CONTRACT CHANGE ORDER

CCO No. 10	Suppl. No. 0	Contract No. 71346	Road U.S. 50 Missouri Flat Road Interchange Phase 1C – Riparian Restoration Project	Federal Number(s) N/A
----------------------	------------------------	------------------------------	--	---------------------------------

**PLANTING PLAN
RIPARIAN
PP-6**

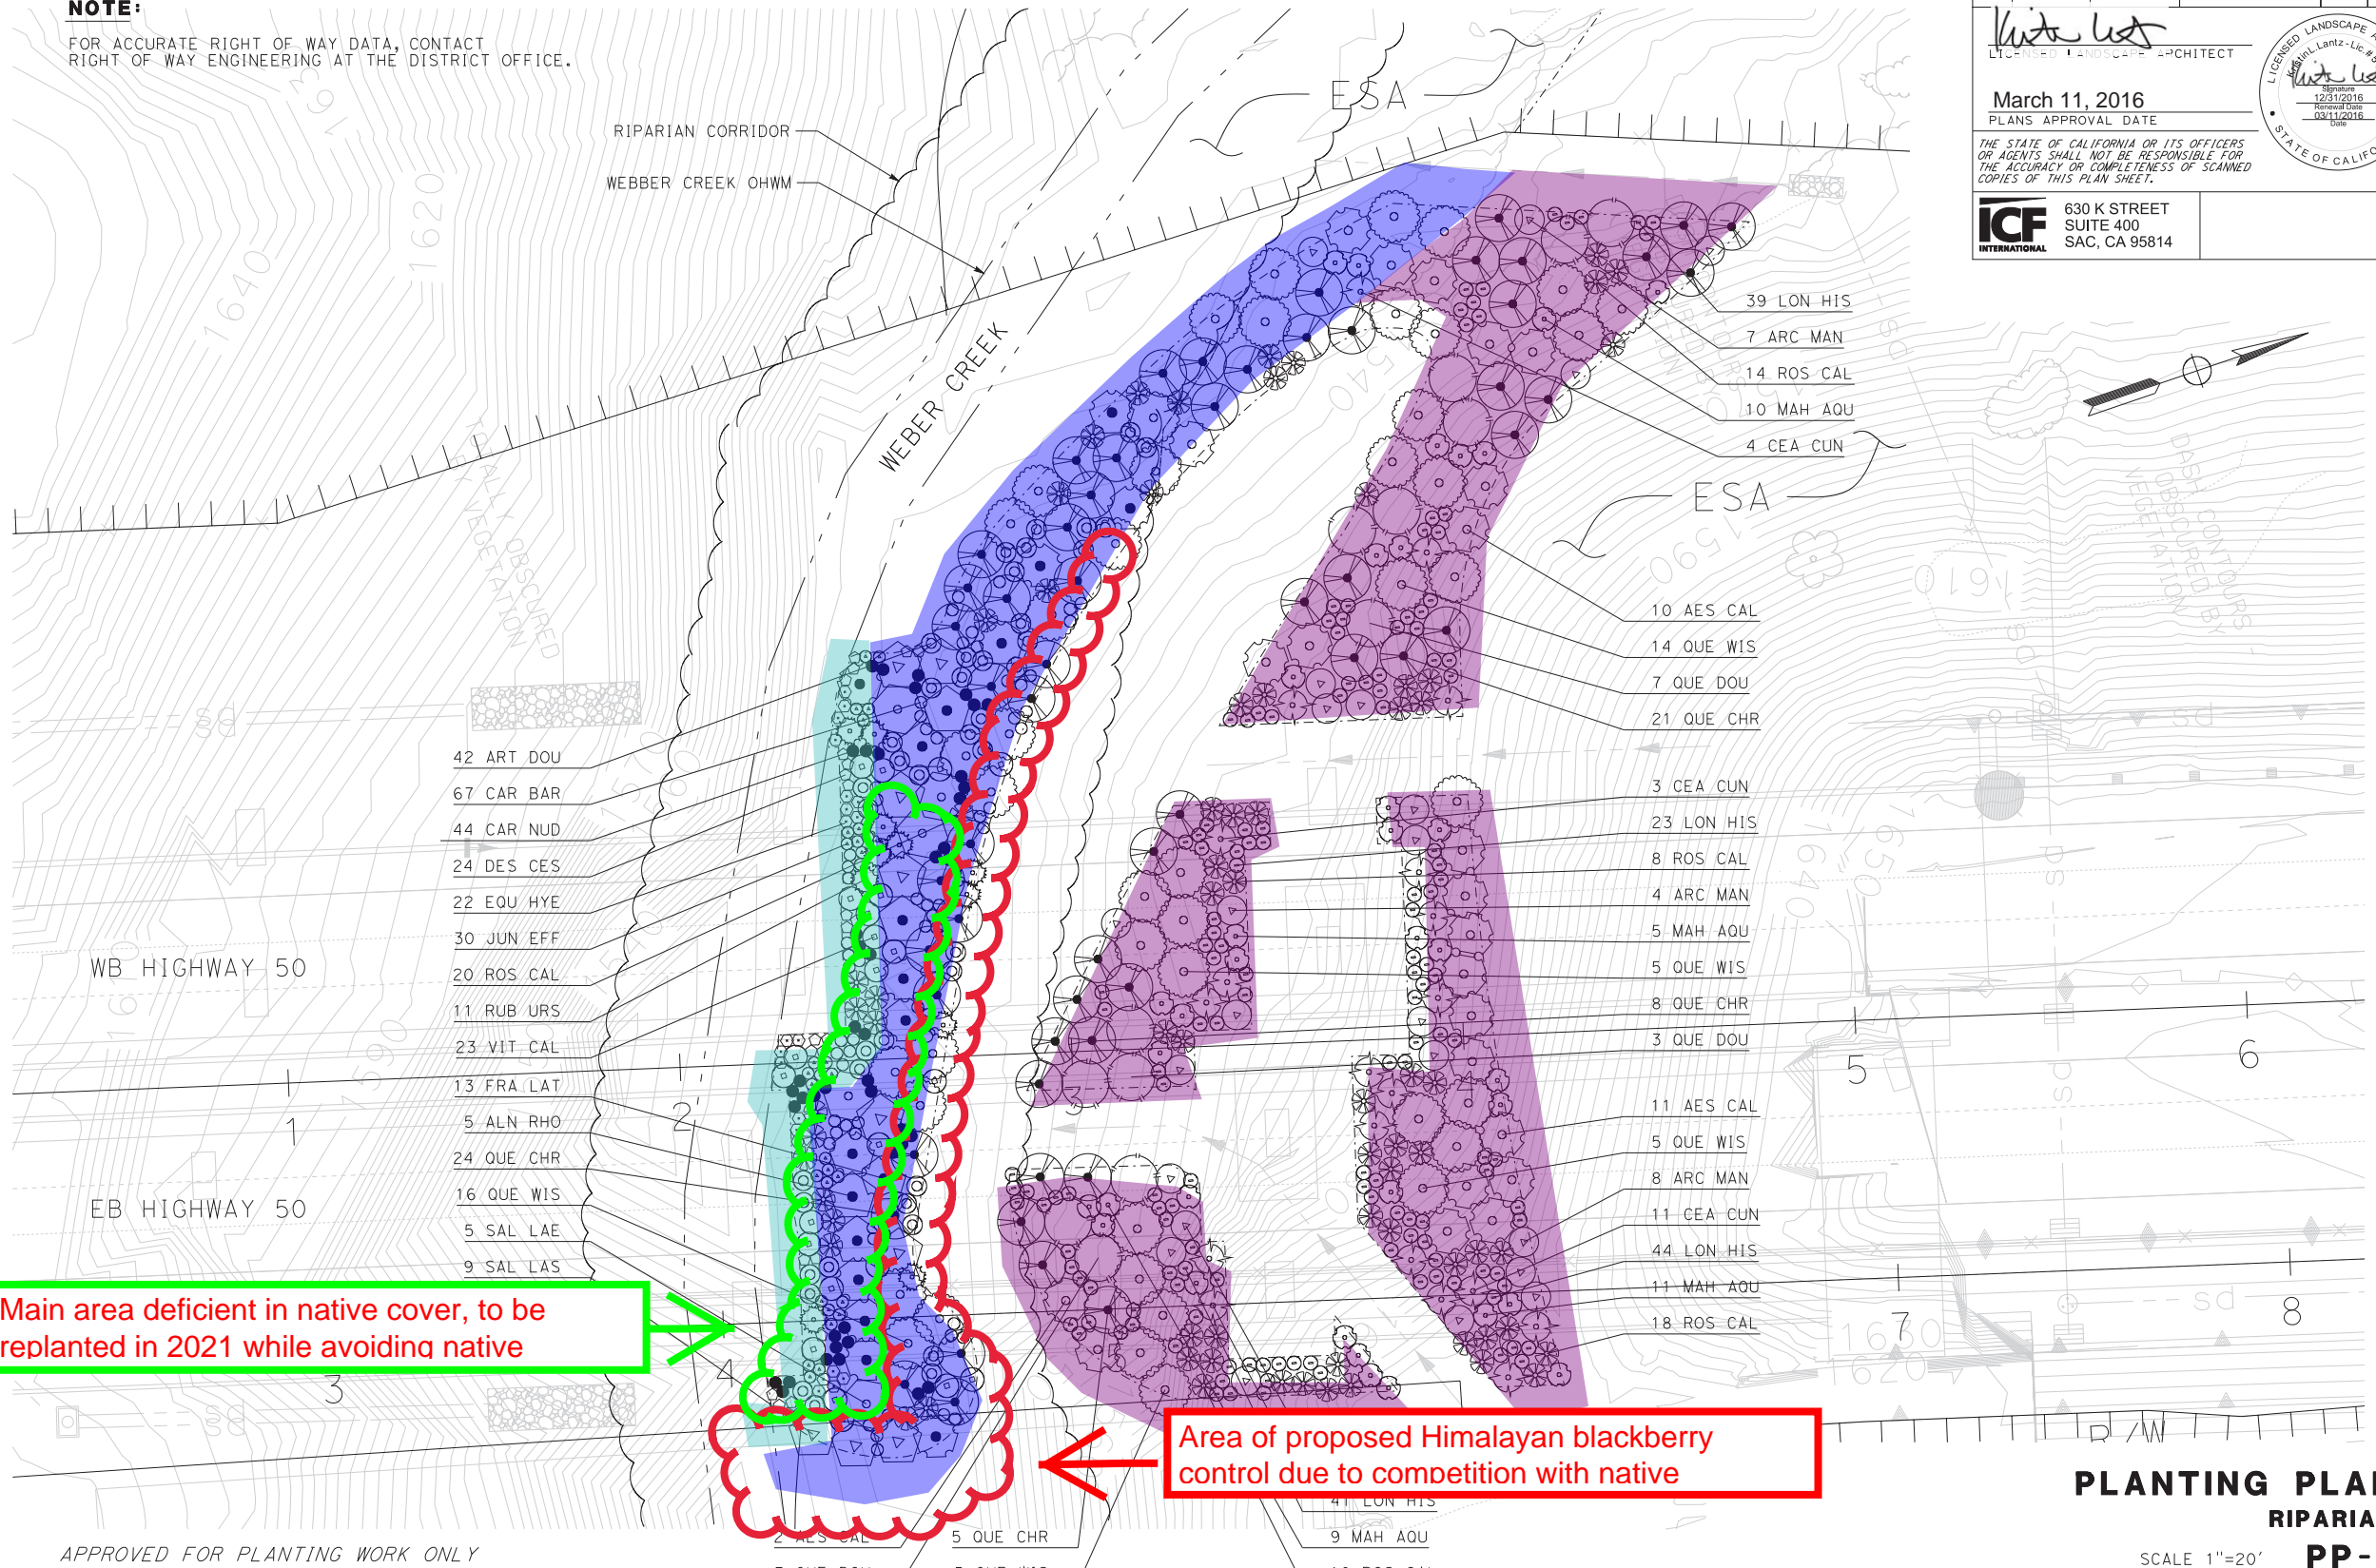
- Prepare the riparian areas shown on Sheet 3 of this contract change order for planting. Preparation of the areas includes removal of weeds necessary for successful planting and installation of temporary irrigation.
- Plant 1-gallon plants of the species and quantities shown in Table 1:

- Include contingency planting to ensure the revised success criteria agreed upon by CDFW will be achieved.
- Extend the plant establishment period to December 31, 2023 for the additional planting in the riparian zone identified on Sheet 3 of this contract change order. All plant establishment requirements as defined in the contract specifications, including monitoring and submittal of annual monitoring reports, must be maintained for the riparian zone through December 31, 2023.
- Remove all temporary irrigation lines installed for the additional planting referenced in Table 1.
- At the end of the plant establishment period remove all irrigation lines installed for the additional planting.

Main area deficient in native cover, to be replanted in 2021 while avoiding native

Area of proposed Himalayan blackberry control due to competition with native
